PICKER X-RAY CORPORATION

Enclosed are scale drawings of the design improvements
I discussed Thursday with Chris and you. I hope this clears
the structural rigidity problems.

3320A SHIPPING CONTAINER
NEW DESIGN CHANGE

HEAD HOLD DOWN BRACKET
NEW DESIGN CHANGE

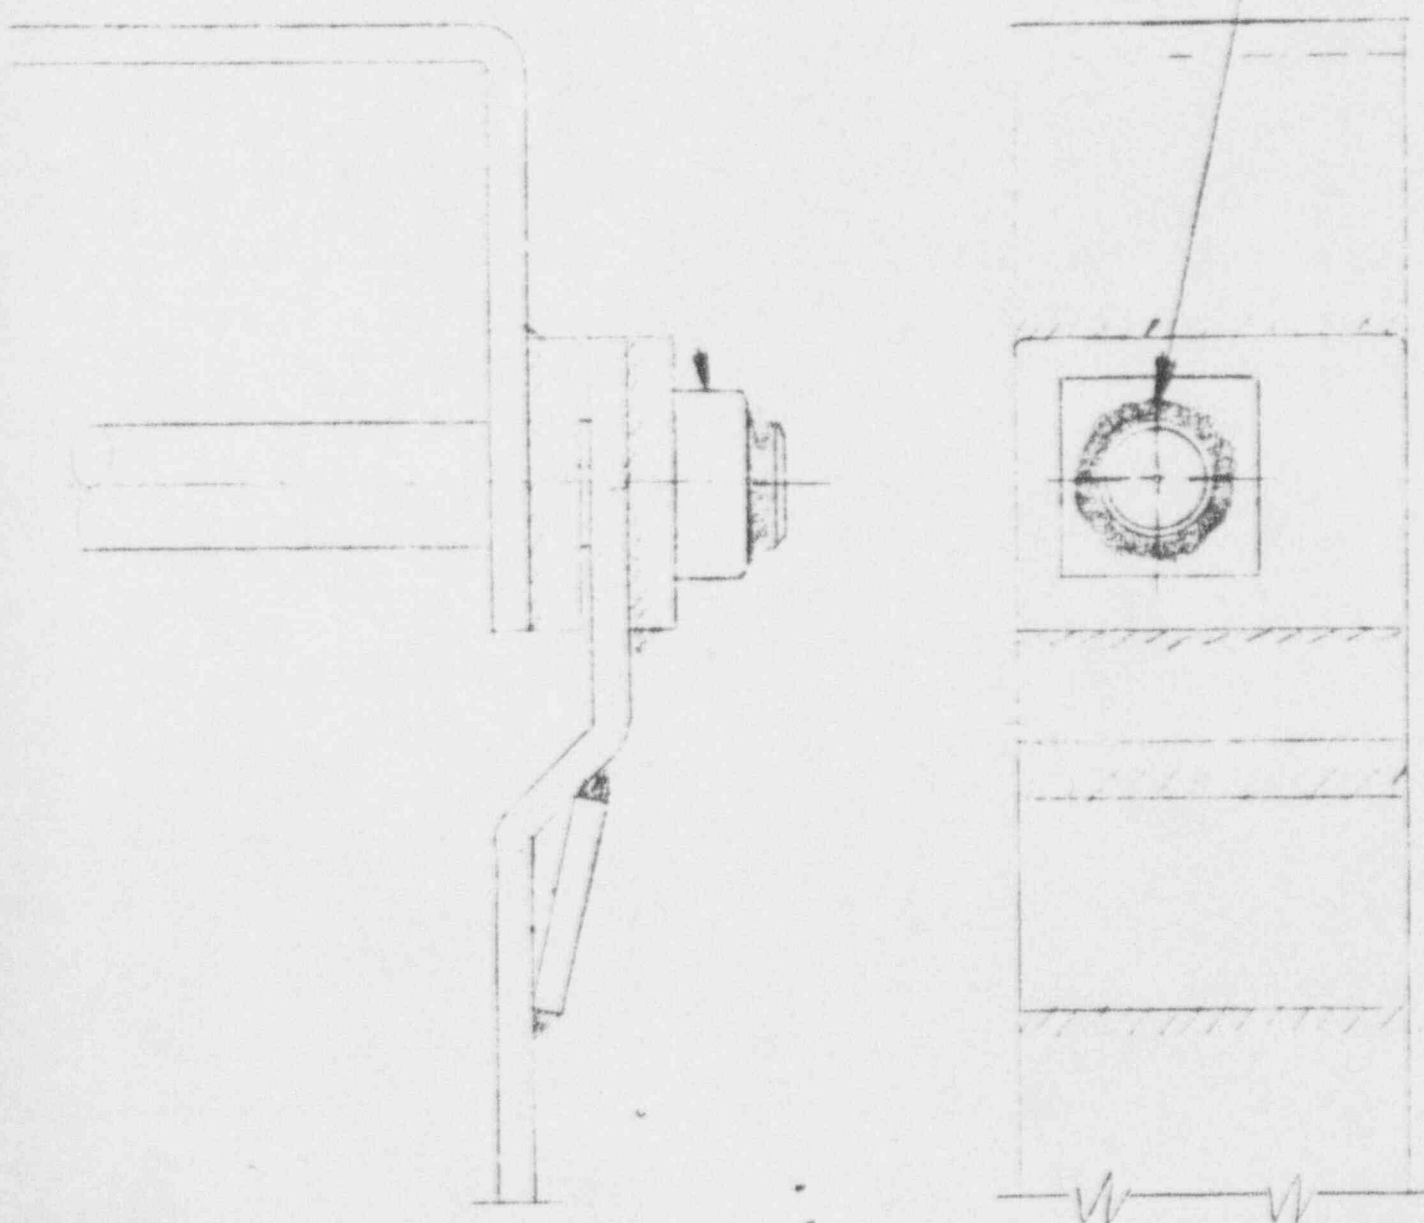
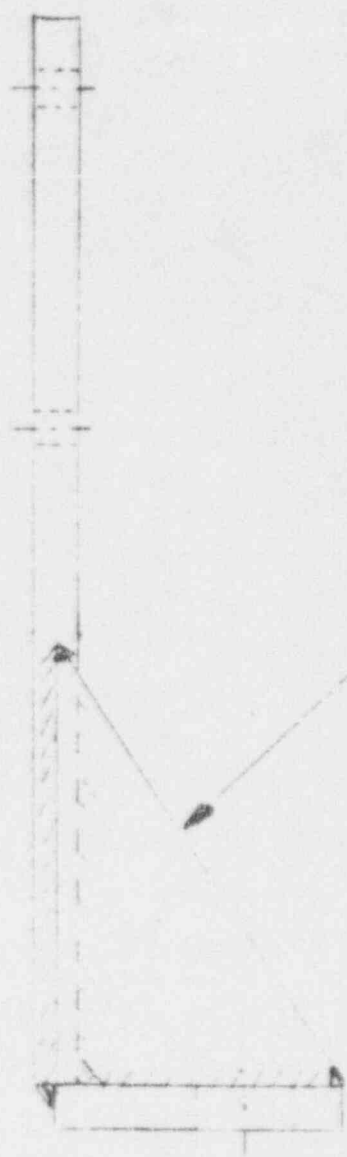
WELL FILLS
CIRCUMFERENCE

-MATH-A.I.S. M.101
2" SQ. X 1/4" T.K.

- MAT'L - A.I.S.I M-1020
1/2 THICK
